SUBJECT: FP-2021-0042
Apex Southeast No. 3

LOCATION: East side of S. Locust Grove Rd.,
approximately ¼ mile south of E. Lake
Hazel Rd., in the NW ¼ of Section 5,
Township 2N., Range 1E.

Final plat consisting of 70 single-family residential buildable lots and 11 common lots on 19.66 acres of land in the R-8 zoning district.

B. Final Plat (dated: 7/16/21)

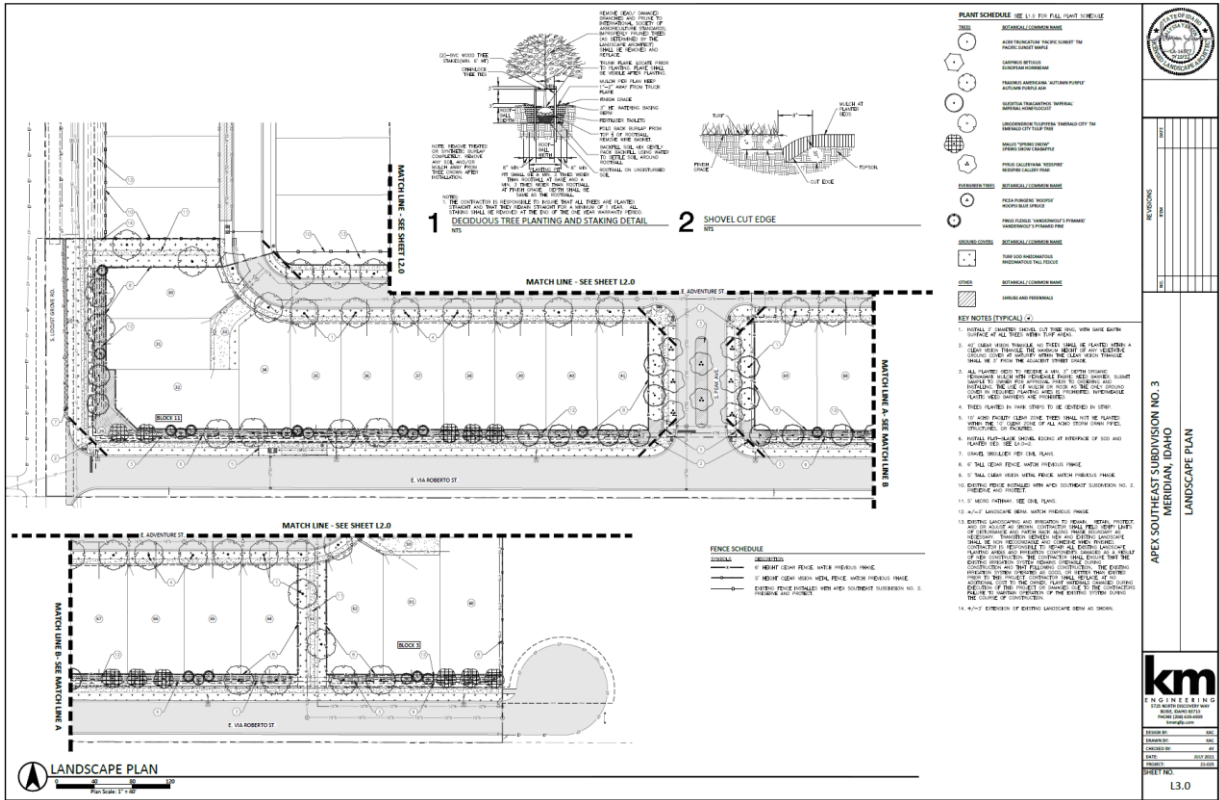
References (Sheet 1):

- a. R1. – Include the Book and Page numbers of the Apex Southeast Subdivision No. 1 plat.
- b. R2. – Include the Book and Page numbers of the Apex Southeast Subdivision No. 2 plat.

Notes (Sheet 3):

- c. Note #5: “. . . Lot ~~44~~7, Block 13 . . .” “. . . owned and maintained by the ~~operator or assigns~~ homeowner's association . . .”
- d. Note #6: “. . . to provide access for Lots ~~51-53~~ 50 and 51, Block 3, ~~Lot 58 and Lots 60-62~~ 60 and 61, Block 3, Lots ~~30 31 and 32 and Lot 34~~, Block 11, respectively. ~~Said 6.~~ Lot 49, Block 3, Lot 59, Block 3, Lot 33, Block 11, shall be owned by the Apex Southeast Homeowner's Association, Inc., or assigns, and the owners of the lots that benefit from the common drives shall maintain, repair and/or replace said common drives at their own cost and expense. ~~Said 6,~~ Lot 49, Block 3. . .”

- e. Note #10: Include the recorded instrument number of the ACHD landscape license agreement.
- f. Note #11: Include the recorded instrument number of the ACHD public right-of-way (sidewalk) easement.

- g. Note #12: “Direct lot or parcel access to S. Locust Grove Rd. and E. Via Roberto St. is prohibited. . .”
- h. Note #15: “. . . Lot ~~44~~7, Block 13, are servient to. . .”

- i. Note #16: Include the recorded instrument number of the CC&R's.

Graphic Depictions:

- j. Sheet 1: Include the CP&F No. at the southeast corner of the site.
- k. Sheet 3: Include the recorded instrument number of the ACHD temporary turnaround easement.
- l. Sheet 4: Include the recorded instrument number of the ACHD permanent easement on Lot 7, Block 13.

D. Common Driveway Exhibits

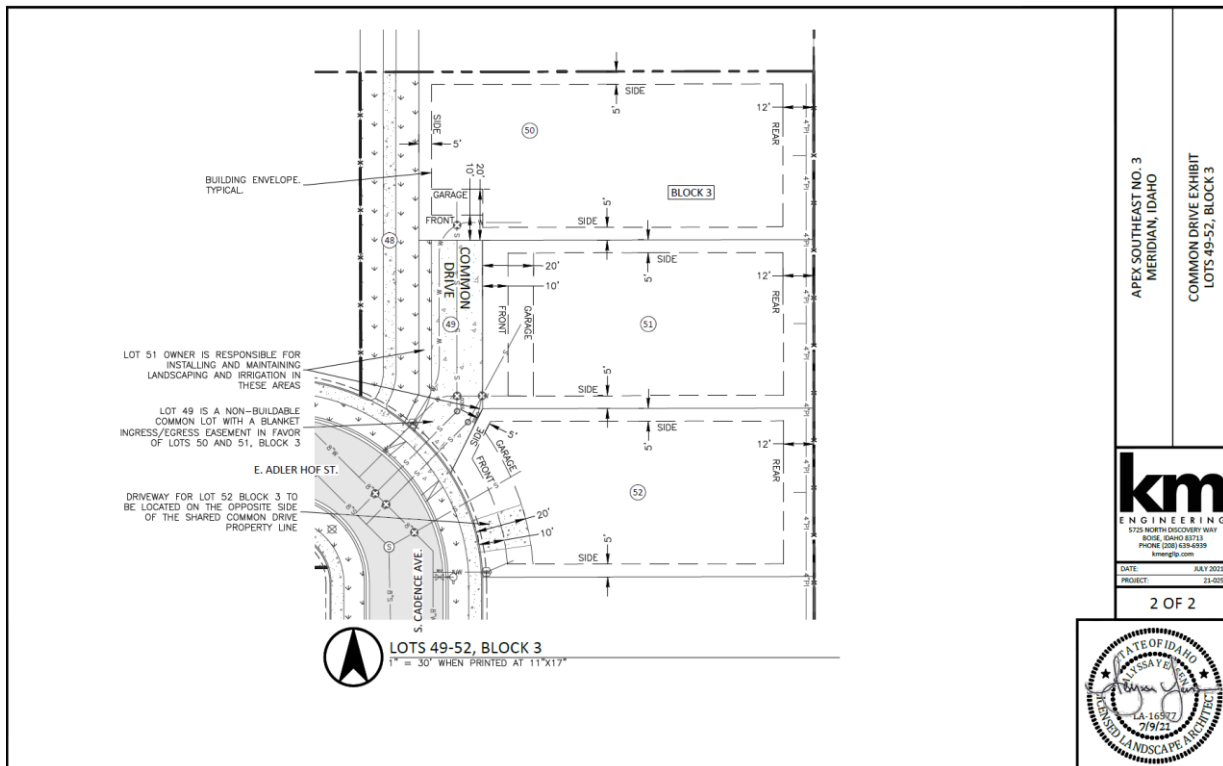
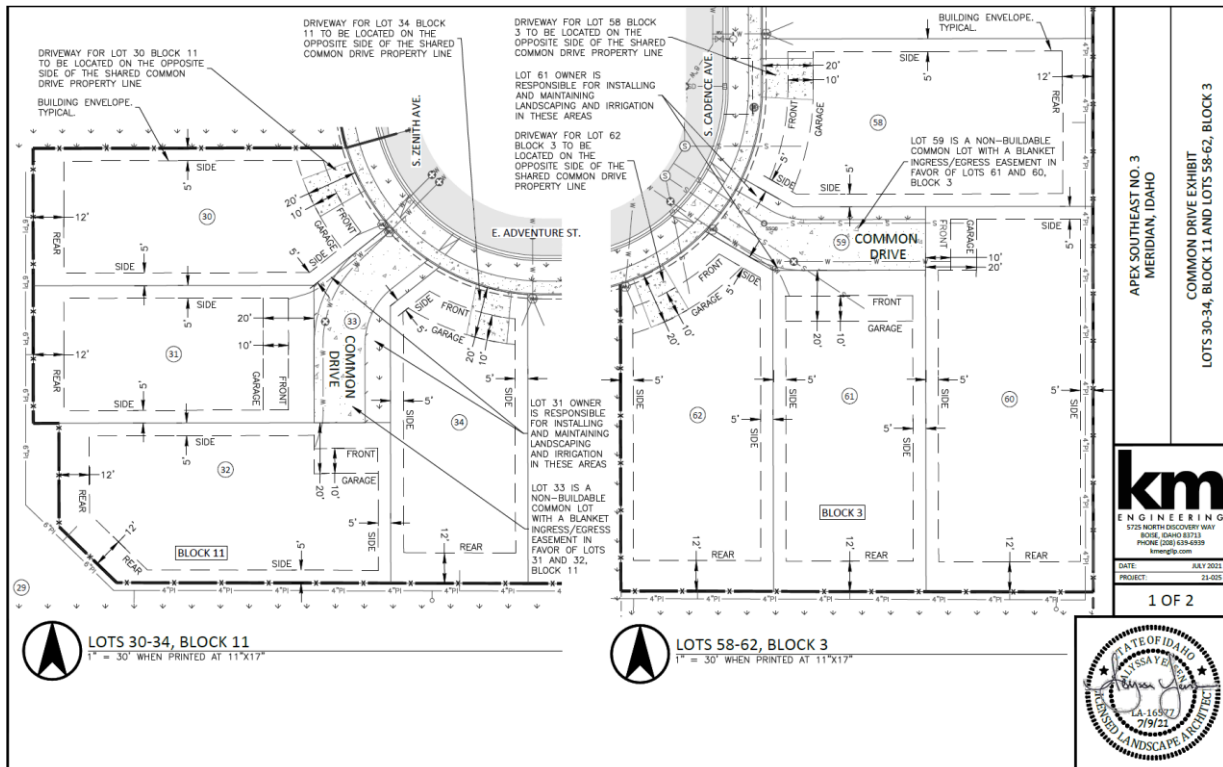
13. The setbacks and/or driveway locations for lots accessed via common driveways or abutting common driveways shall be as shown on the exhibit in Section V.D (applies to Lots 50-52, 58, and 60-62, Block 3; and Lots 30-32 and 34, Block 11).
